PCN / EOL Notification

Product Change Notification Number: RC091302

Title: AT91SAM9261 Revision and Ordering Code Change

Top side marking:

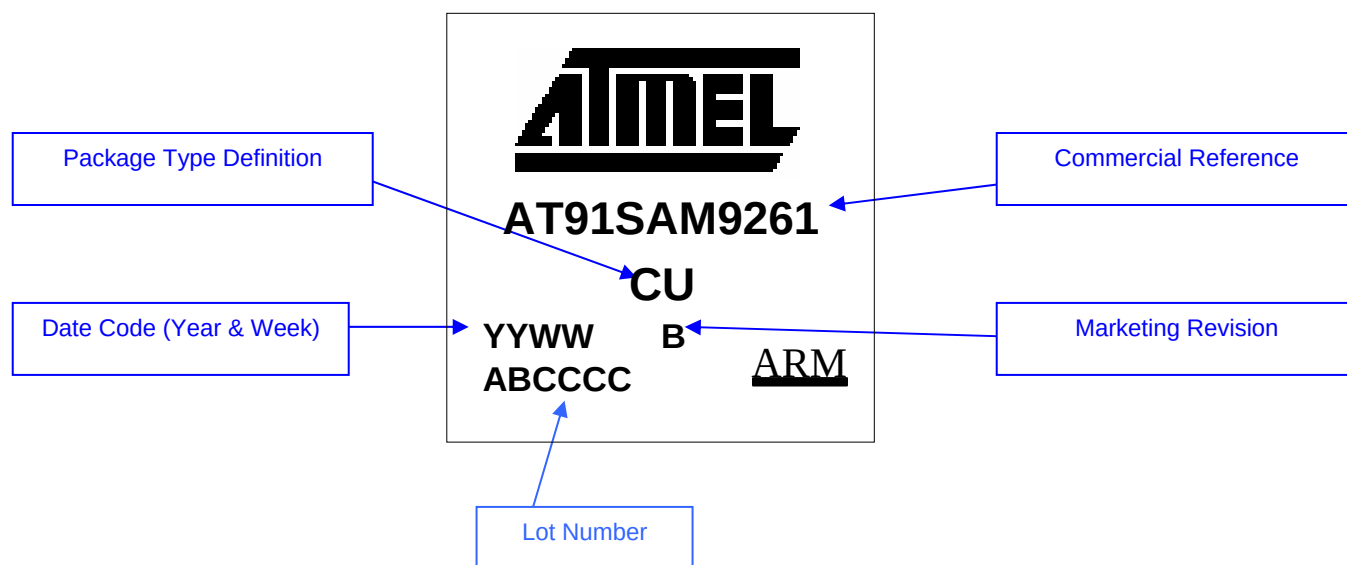
Marketing Revision on the topside marking will be incremented from A to **B**.
